Independent Expert Recommendations to Queensland Competition Authority

Response to Aurizon Network's Detailed Response to the ICAR 2021

Date: 17 June 2022

Figure 6: Newlands and GAPE Transitional Arrangement Bridge

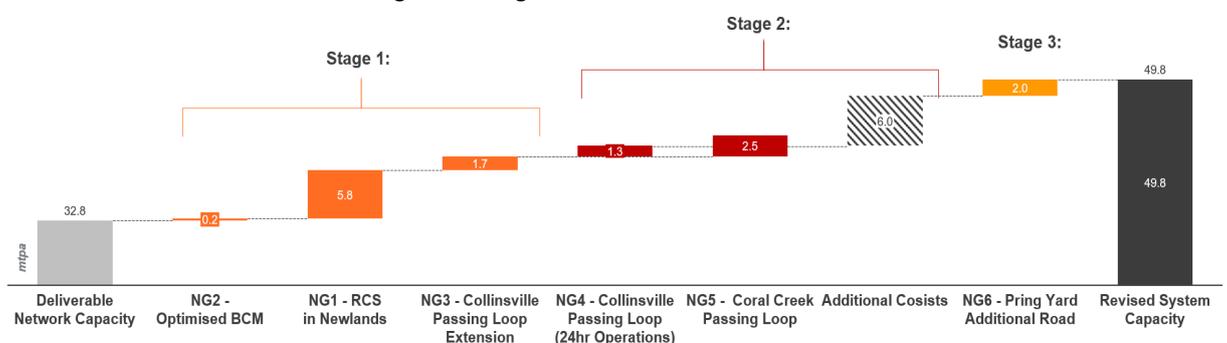
6.3 Independent Expert Analysis of Proposed Transitional Arrangements

Transitional Arrangement	Effective Score ¹ [Low to High]	Efficient Score ² [Low to High]	Industry Support ³	Risk ⁴	Overall Score ⁵
NG1: RCS in Newlands			92%		1
NG2: Optimised BCM Program			92%		0
NG3: Collinsville Passing Loop Extension (day time)			92%		1
IE-NG3A: Collinsville Passing Loop Extension (14 hrs) - with cost risk			92%		2
NG4: Collinsville Passing Loop (24hrs a day)			58%		5
NG5: Coral Creek Passing Loop			58%		3
IE-NG5A: Coral Creek Passing Loop + Collinsville Pass Loop (day time)			58%		4
NG6: Pring Yard Additional Road			25%		12

Based on the review process outlined above, the Independent Expert is recommending the way forward for Newlands/GAPE Transitional Arrangements as shown in **table 8**. A comparison of IE recommendations to Aurizon Networks recommendations is also shown.

Coal System	Transitional Arrangement Project	IE Recommendation	Staged Review	Aurizon Recommendation Comparison	Comments
Newlands/GAPE					
NG1	RCS in Newlands	Immediate implementation	✘	Agree	
NG2	Optimised Ballast Cleaning Machine program	Immediate implementation	✘	Agree	
NG3	Collinsville Passing Loop Extension (day-time operation)	Immediate implementation	✔	Agree	This project proceeding immediately is dependent on Above Rail approval and no extension (additional costs) being required. Should this not occur then it is recommended that a further staged review be undertaken before being implemented
NG4	Collinsville Passing Loop 24 hour operation	Concept study undertaken	✔	Partial Agree	Concept study should proceed if day-time operations is implemented.
NG5	Coral Creek Passing	Hold ¹	✔	Partial Agree	Further work on Coral Creek Passing Loop to occur only after Staged review of Collinsville Loop 24 hour operation.

NG5A ²	Coral Creek Passing Loop + Collinsville Passing Loop (day- time operations)	Hold	✔	Not considered	Aurizon Network analysis did not consider the option of running Coral Creek Passing Loop and Collinsville Passing Loop (day-time operation only) together. There is a capacity benefit to do so. Review as part of staged review process.
NG6	Pring Yard Additional Road	Hold	✔	Agree	No further immediate work undertaken until staged review of other projects confirms remaining ECD

-	Consist Number Increase	Implement as required	✘	Agree	While not a below rail project it is highly recommended that consist numbers are increased to release additional capacity as required

Figure 9: Aurizon Network Goonyella Transitional Arrangement Bridge

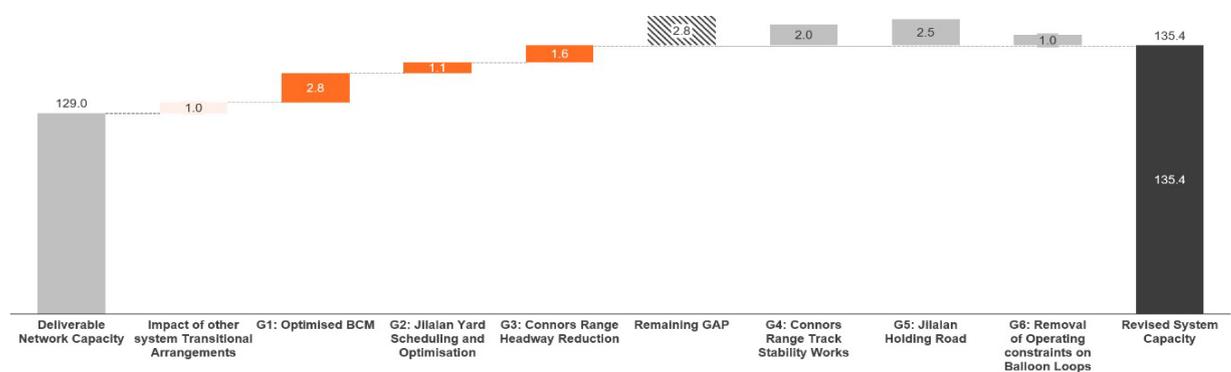
7.3 Independent Expert Analysis of Proposed Transitional Arrangements

-	Longer Delivery Windows at DBCT	Review	✔		While not a Below Rail project the longer delivery windows change that was implemented in early 2022 needs to be assessed as part of staged review to determine impact on capacity.

Figure 11: Blackwater & Moura Transitional Arrangement Bridge

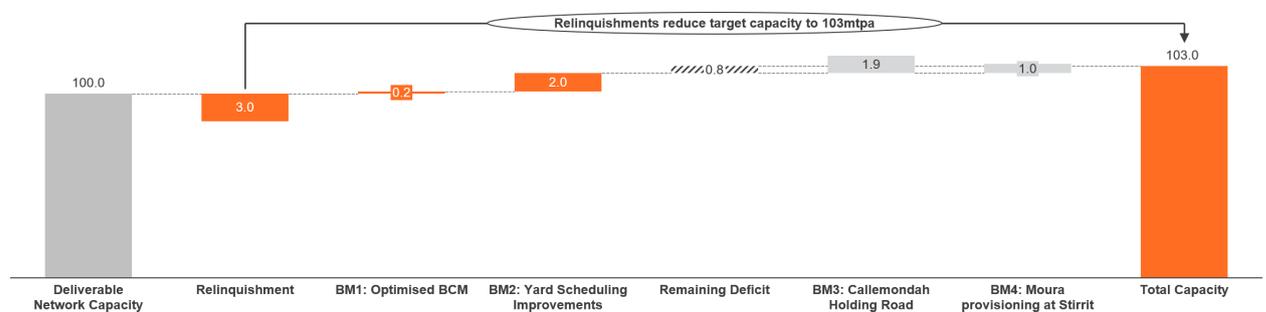
8.3 Independent Expert Analysis of Proposed Transitional Arrangements

Given the small outstanding Existing Capacity Deficit, at this point in time it is recommended that the BM3 Callemondah Yard Additional Road and BM4 Moura provisioning at Stirrit projects should remain as potential opportunities however no further work (ie placed on Hold) until the impact of projects BM1 and BM2 can be assessed and in conjunction with the Annual Capacity Assessment process determines the remaining ECD to be resolved.
